Technical Homework Questions

Answers to Questions

Jefferson Lab Moller Project Director's Review

January 15, 2020

BCM systematics

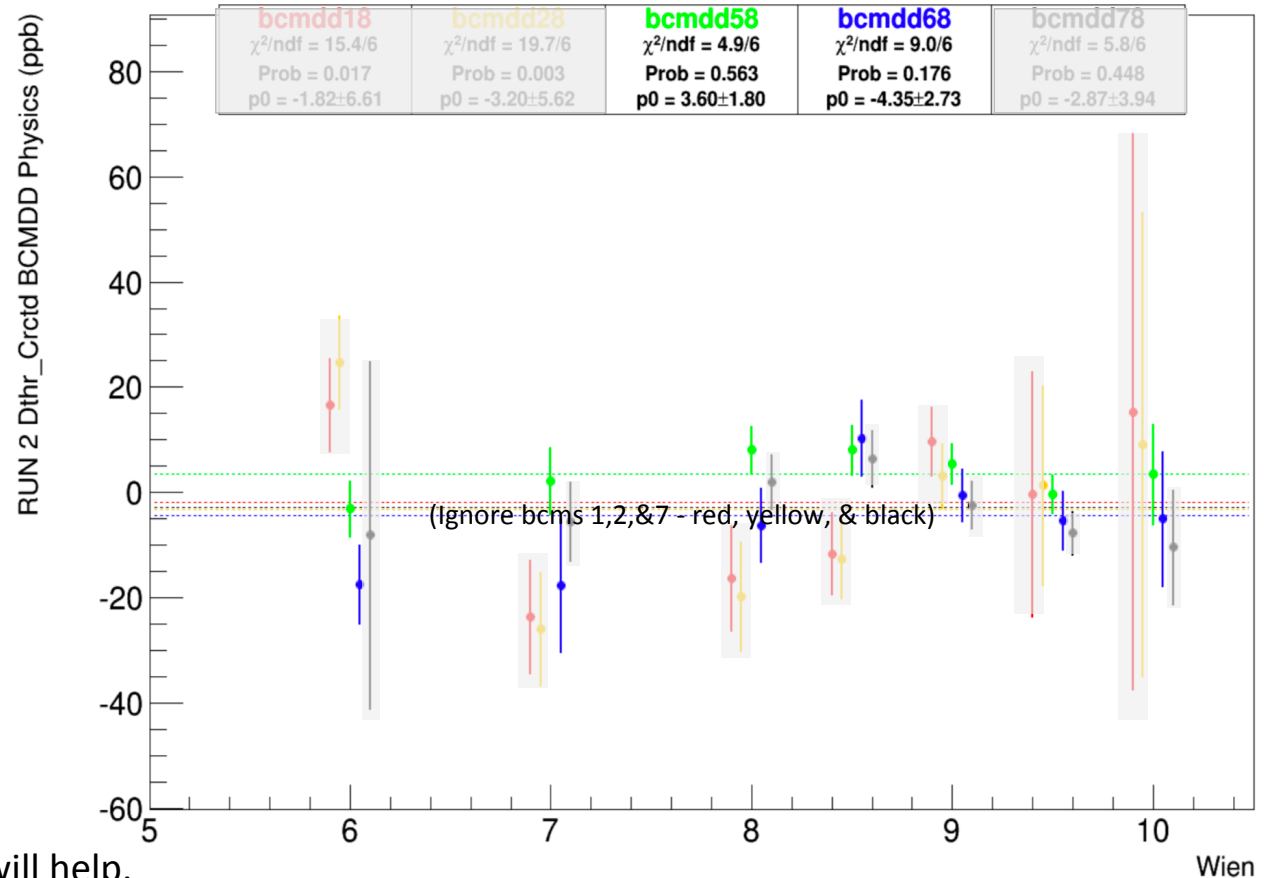
Reasonable agreement between BCMs for short time intervals (runs, slugs), but marginal discrepancies emerge with “wien level” comparisons, suggesting systematic bias between monitors or else very unfortunate statistical variation

The precision of the BCMs was marginal for testing this before the end of the run.

Greater number of functional monitors (7) will help.

Better resolution (either in digital-to-analog or the new all-digital LBNL system) would be a big help, providing a way to consistency during the run.

BCM Reproducibility issue from Qweak

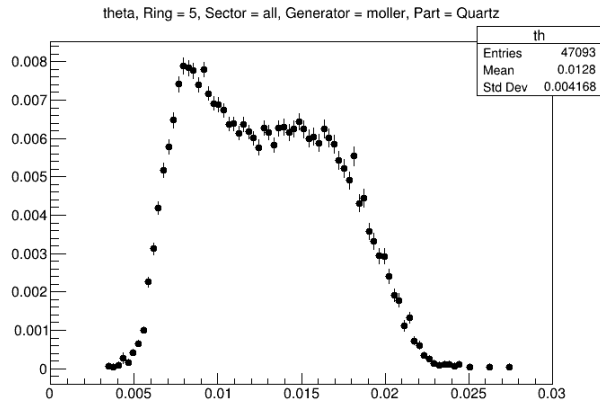
The consistency between the charge measurements from the 3 monitors can be extracted by normalizing the detector asymmetry by each individual BCM in sequence:

If the BCMs were reproducible, these three numbers should agree within statistical errors. The p -value based on $\chi^2/dof = 4.54$ for these three numbers to be consistent is 10.3%, *i.e.* no statistically significant evidence for non-reproducibility of the BCMs.

Homework Question 2 Answer, part 1

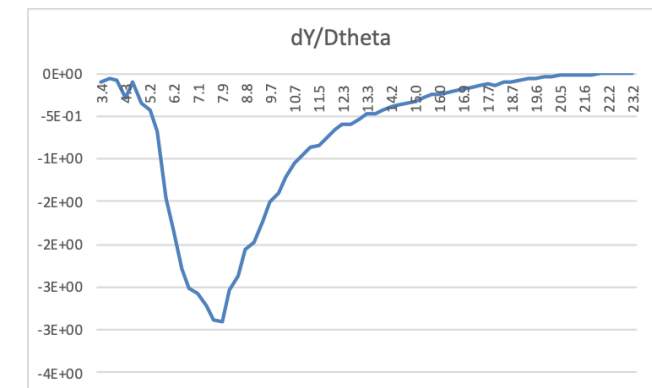
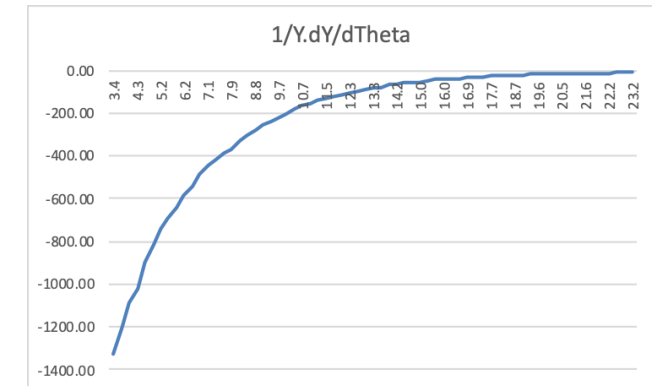
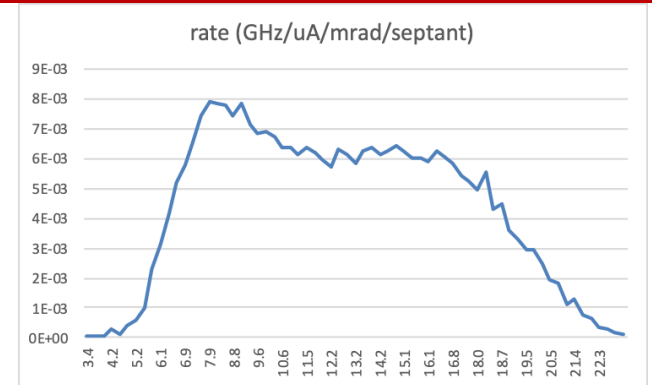
Sensitivity as a function of angle $\frac{1}{Y_i} \frac{dY_i}{d\theta_i}$

$$\text{Sensitivity } \frac{1}{Y} \frac{dY}{d\theta} = -165 \text{ ppm}/\mu\text{rad}$$

$$\pm 150 \mu\text{rad} * 165 \text{ ppm}/\mu\text{rad} = \pm 25000 \text{ ppm} = 2.5\%$$
